SIB 64 01 24

2024-02-20

RYTHMIC DRUM NOISE HEARD FROM HVAC

This Service Information Bulletin (Revision 1) replaces SI B64 01 24 **dated January 2024**.

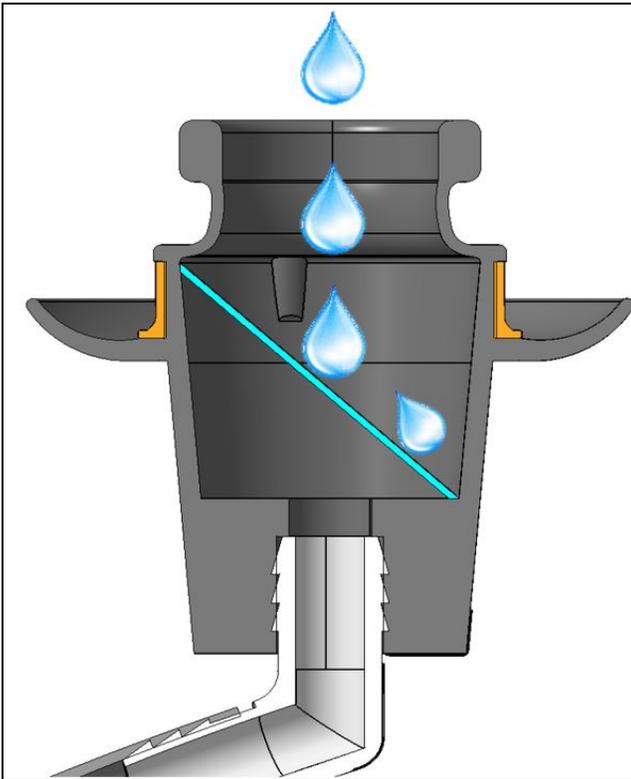
A drumming noise is heard when the air conditioning system is operating.

Warm temperatures combined with high air humidity may lead to the formation of condensate in the blower housing.

As a result of a high blower actuation, the formed condensate droplets are thrown vertically against the condensation drain opening at high speeds.

The resulting noise is amplified by the long condensation drainage hose, and by the geometry of the grommet and heating and air conditioning unit. These can result in an echoing effect heard from the condensate drain pipe.

A ramp insert has been placed into the condensation drain plug, so the water drops falling into the condensate drain pipe are broken up- eliminating the drumming noise.

For vehicles produced prior to December 2023, replace the condensation water drain (shown here in dark grey).

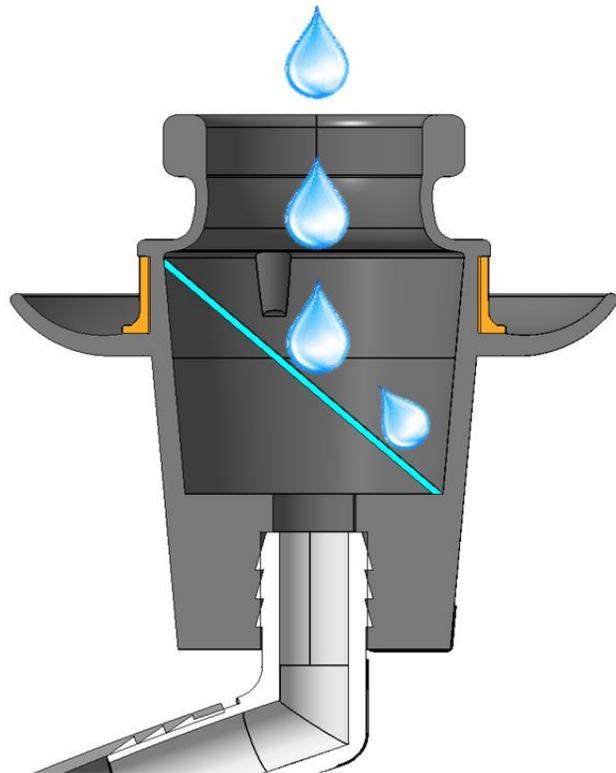
Replace the condensation water drain.

NOTE: DO NOT MODIFY the condensate drain pipe. This could allow water to collect upon the high voltage battery or back up into the HVAC box overflowing onto the vehicle floor.

The condensation drain has been optimized and can be identified by a **WHITE DOT** or revision **INDEX 02** or higher.

Prior to installing new drain into body from below apply lubricant to the top of the seal (2) where it contacts the heater box.

NOTE: *This image was taken from inside vehicle with HVAC box removed for clarity. You do not need to access vehicle from inside the passenger compartment.*
